REMARKS

ABSTRACT OF THE DISCLOSURE

FIG. 1

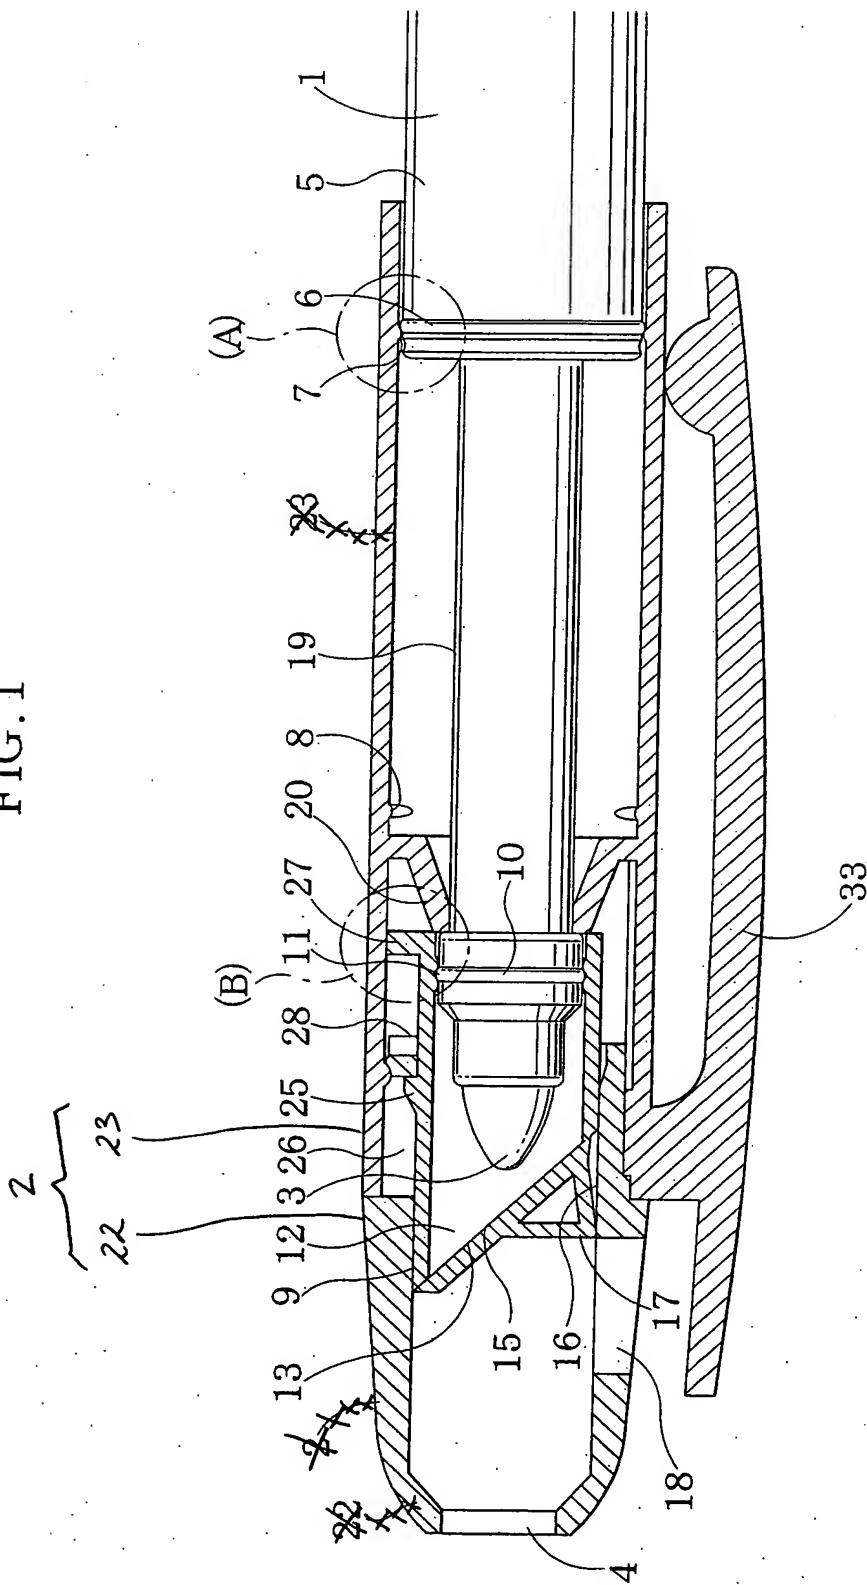
Submitted herewith are replacement sheets for Figs. 1, 3-7 and 12 incorporating revisions to overcome drawing objections. More specifically, Figs. 1, 5, 6, 7 have been revised to correctly designate the components 22-23 of the barrel 2, Fig. 3 has been revised to remove reference numeral "2", and Figs. 4 and 12 have been revised to show the rib 17 and 139, respectively, in phantom lines. Also submitted are
